**STATE OF MARYLAND  
CRITICAL AREA COMMISSION  
CHESAPEAKE AND ATLANTIC COASTAL BAYS**

May 21, 2010

Re: Liberty Sand & Gravel Lots 13, 15 & 16 Resub/White Cedar  
S 01-083, P 03-0064-000F

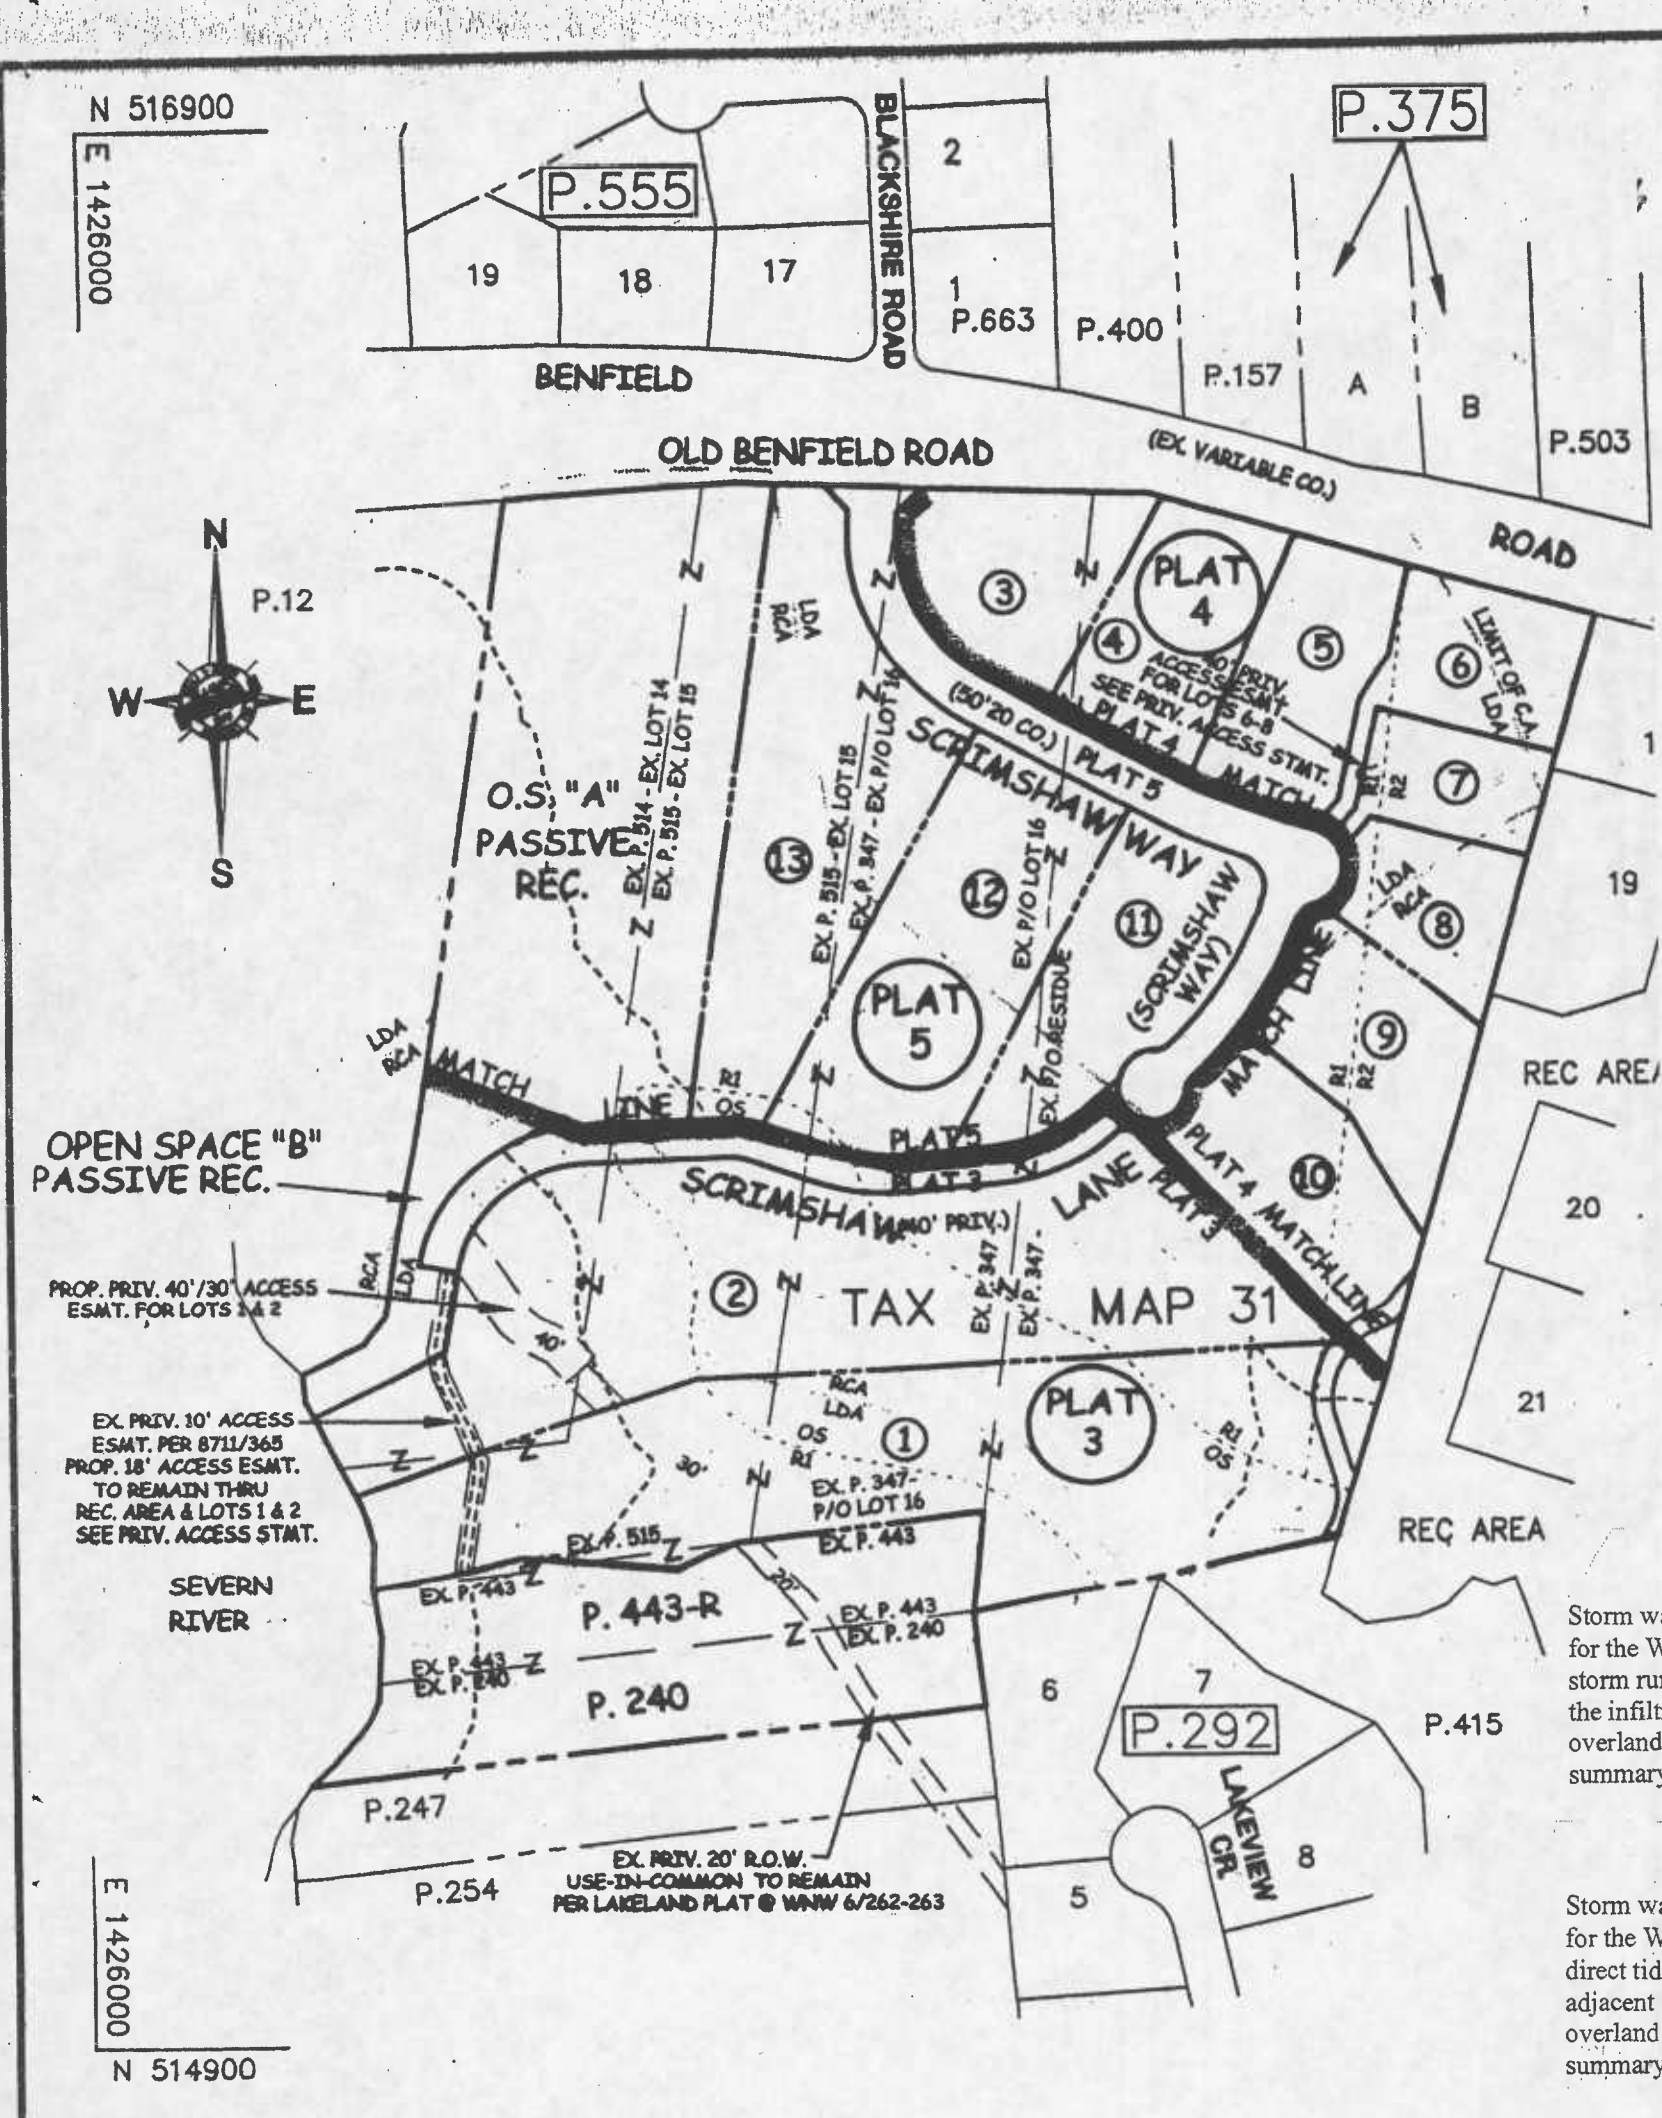
- 2) In response to this office's previous comment letter, the applicant states that no clearing will be required in the 100-foot Buffer to make use of the gravel road in the Buffer to access proposed lot 2. However, the applicant's plans show the existing treeline encompassing the road in several locations, and sheets 3 and 4 of 7 show proposed clearing in the Buffer. Please have the applicant explain the conflicting information.

- 3) As the applicant has noted in the response to this office's previous comment letter, the 100-foot Buffer to Stevens Creek must be expanded to include contiguous nontidal wetlands and contiguous slopes 15% and greater, as well as the lands 50 feet from the top of those slopes. The applicant indicates that such an expanded Buffer has been mapped on the plans, yet it does not appear that this expanded Buffer is shown on the plans received by this office. Once this

expanded Buffer is mapped on the plans, it may overlap with the proposed limits of disturbance for lot 1. If this is the case, the proposed development on lot 1 will need to be reconfigured.
